Sent: 18/02/2020 10:19:51 PM
Subject: 1 Tabalum Road, Balgowlah Heights 2093 DA 2020/0077 Submission:
Bawmer WRITTEN SUBMISSION: LETTER OF OBJECTION
Attachments: Submission Bawmer DA 2020 0077.docx;

1 Tabalum Road, Balgowlah Heights 2093

DA 2020/0077

WRITTEN SUBMISSION: LETTER OF OBJECTION

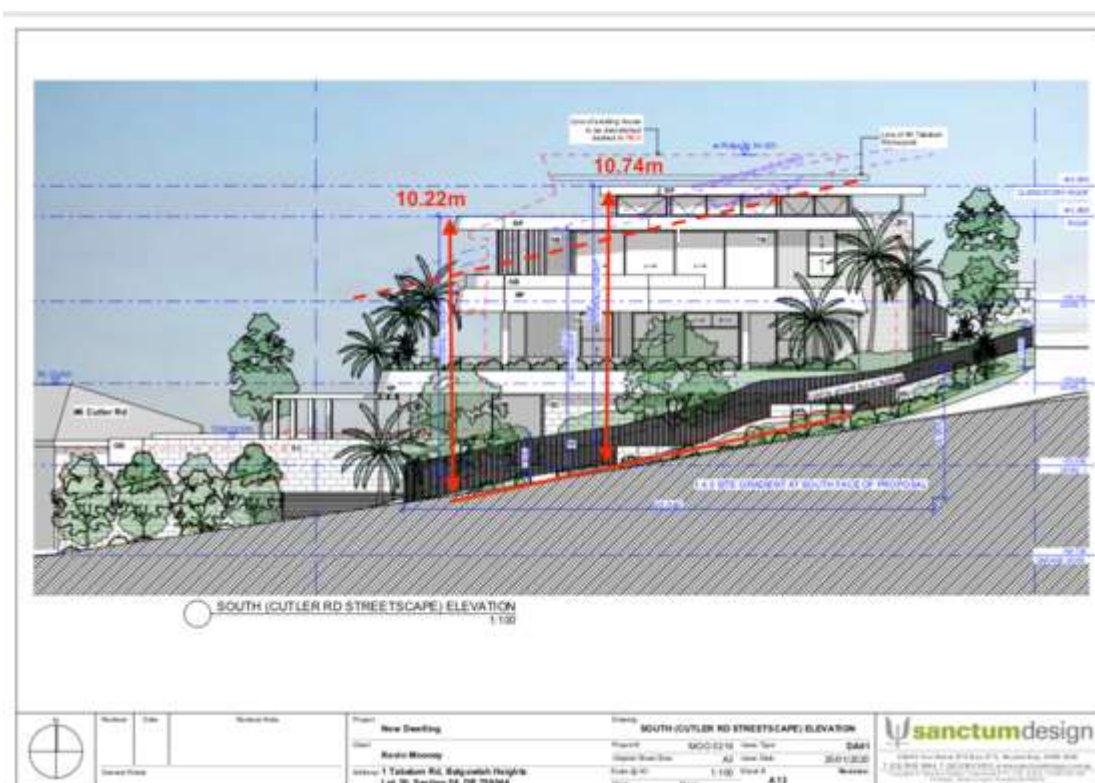
The proposed development does not step with the topography of the land.

The SEE fails to state that the proposed development presents substantial non-compliance of Height of Building, FSR, Wall Height, Front Setback, Side Setback, and Rear Setback controls.

The SEE fails to justify the deep basement, and the obvious poor environment outcomes.

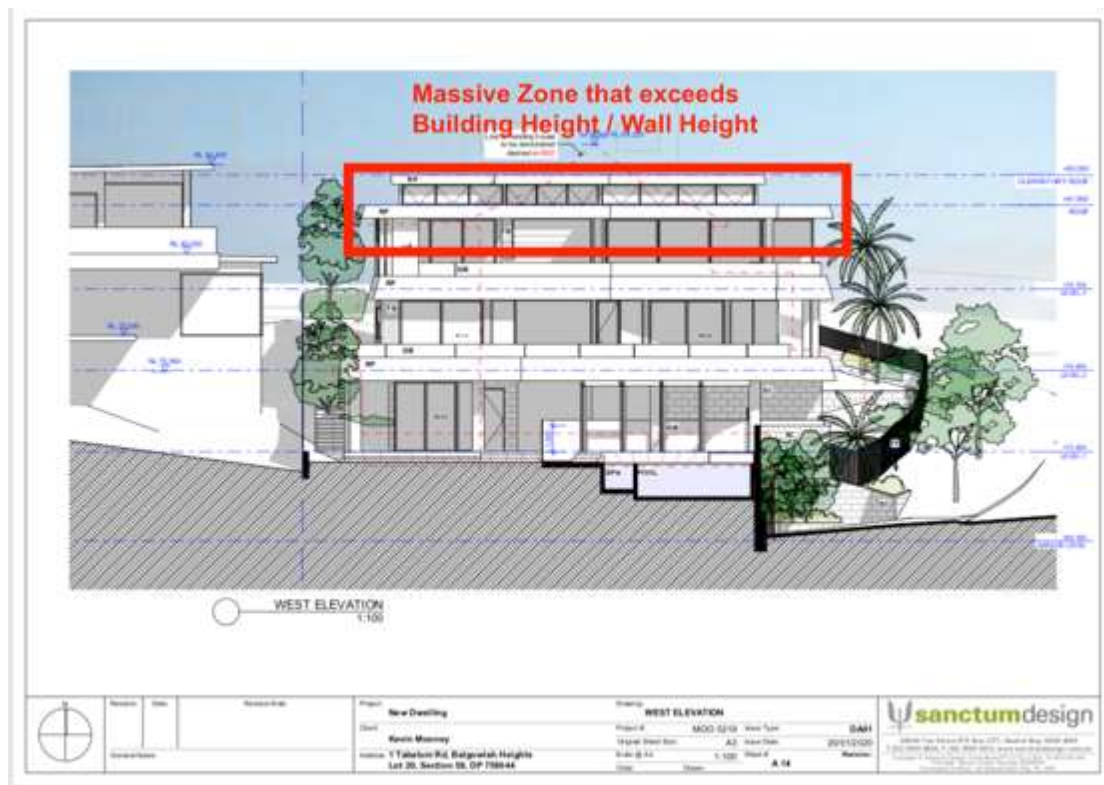
Massive zone facing #6 Cutler that exceeds building height and wall height. Note false and misleading existing grounds levels to #3 Tabalum that do not accord with the Applicant's survey. #3 Tabalum land sits up to 1.7m higher than the subject site, however the Applicant is trying to suggest that it is lower. False and Misleading.

I ask that Council insist that the Applicant positions on each Plan, Elevation and Section the precise Existing Ground Levels from the Applicant's Survey and to adjust the maximum height envelope accordingly.

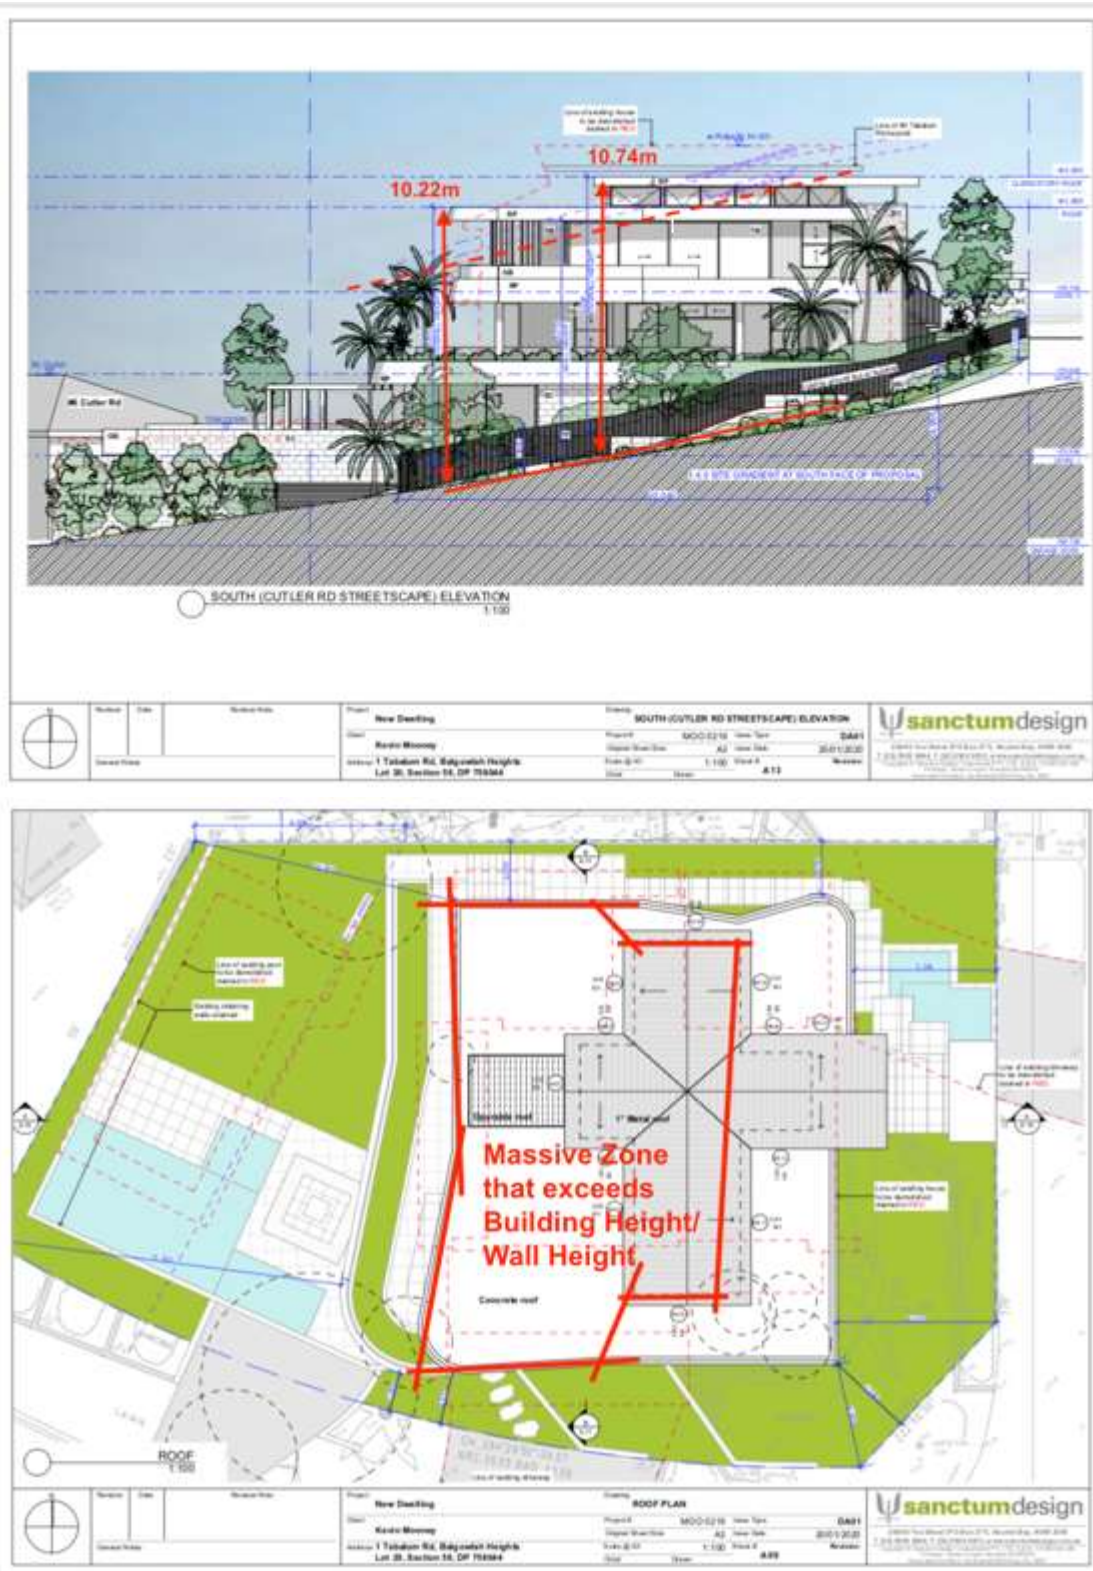
Proposed 10.74 m [clerestory at SW corner, survey RL 72.31] and 10.22m [roof at SW corner, survey RL 71.68]

The proposed development does not provide for building heights and roof forms that are consistent with the topographic landscape, prevailing building height and desired future streetscape character in the locality. The proposed development does not control the bulk and scale of buildings.

The proposed development does not minimise disruption to the views to nearby residential development from public spaces (including the harbour and foreshores), views from nearby residential development to public spaces

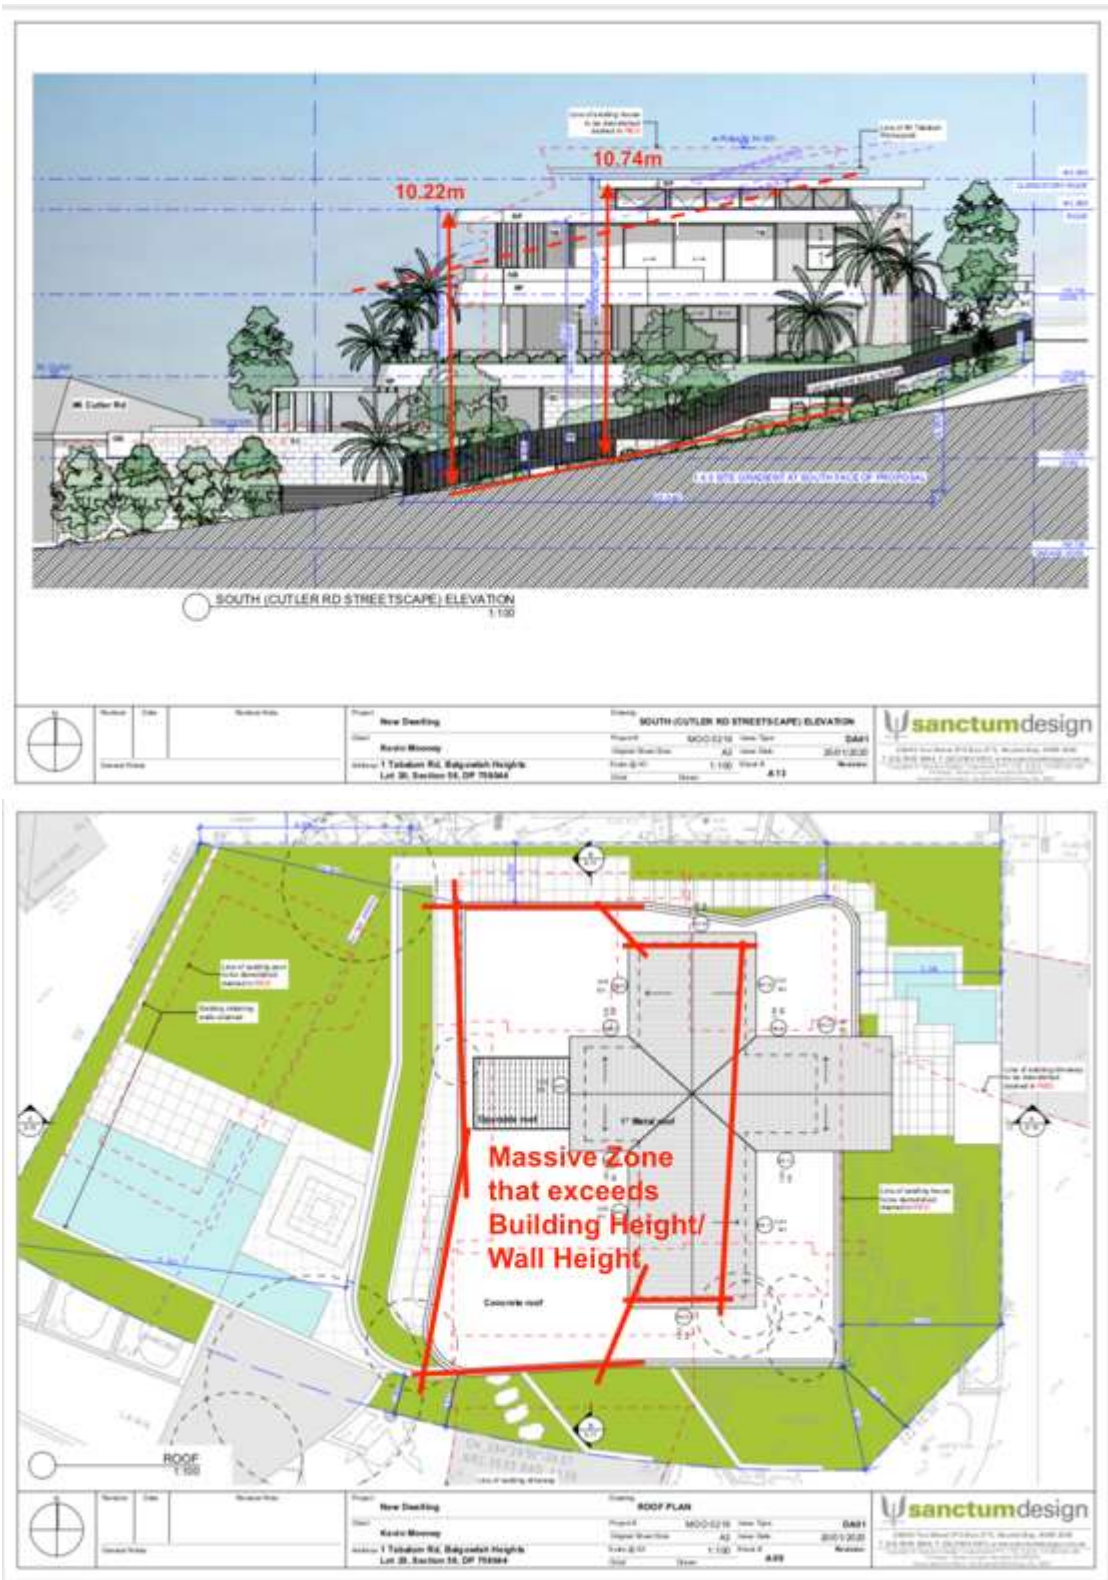
Proposed 10.74 m [clerestory at SW corner, survey RL 72.31] and 10.22m [roof at SW corner, survey RL 71.68]

The proposed development does not provide for building heights and roof forms that are consistent with the topographic landscape, prevailing building height and desired future streetscape character in the locality. The proposed development does not control the bulk and scale of buildings.

The proposed development does not minimise disruption to the views to nearby residential development from public spaces (including the harbour and foreshores), views from nearby residential development to public spaces (including the harbour and foreshores), and views between public spaces (including the harbour and foreshores).

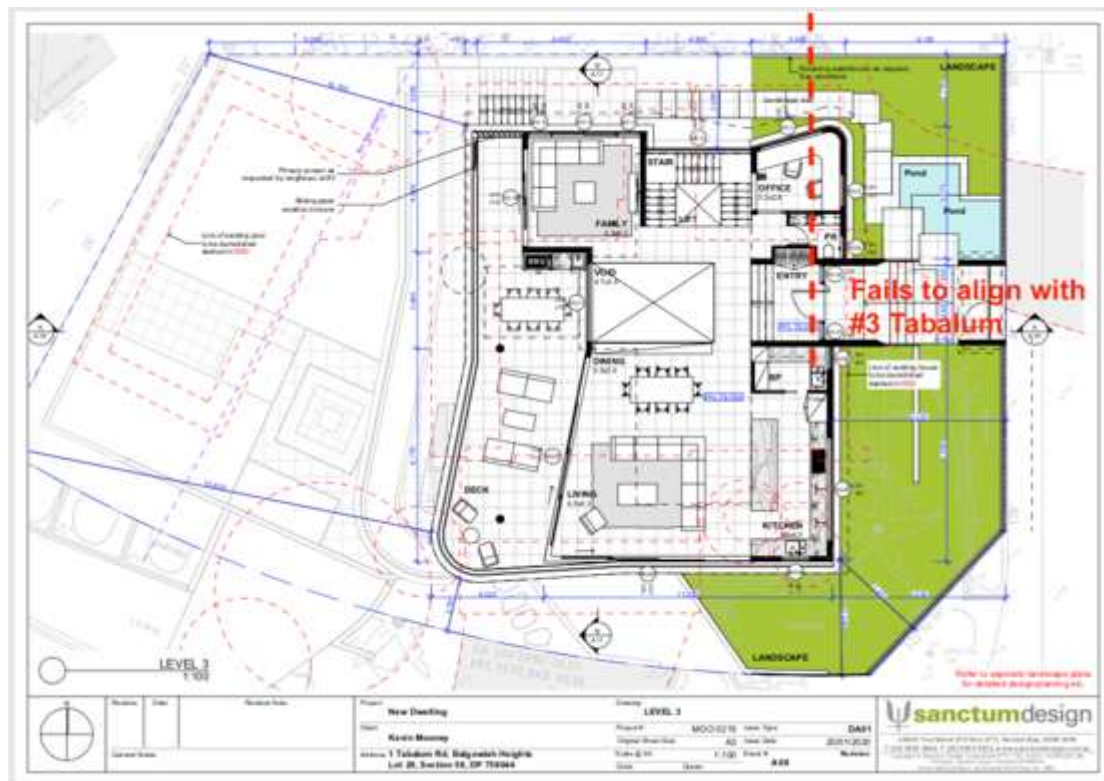
Control #3 Tabalum at 7.0m

Proposed 6.13 m

I ask for a compliant front setback that relates to 3 Tabalum.

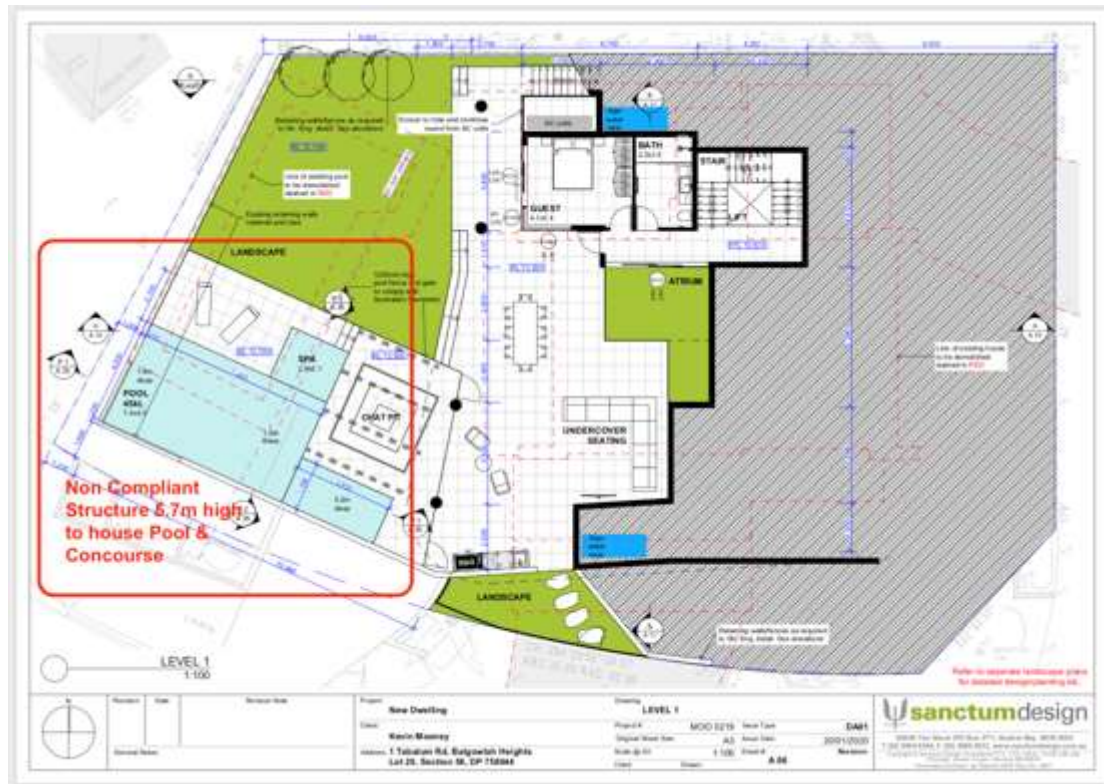
The new structure is part of the building considering that the built form rises to RL 73.9 over the adjacent levels at the south-west corner at RL 68.18. This

represents wall heights of up to 5.72m, which is effectively a two storey structure, built into the rear setback zone.

This structure is built only 1.23m from the western boundary, and 1.685m from the southern street boundary.

No consideration to privacy, additional overshadowing, and visual bulk has been considered in this respect.
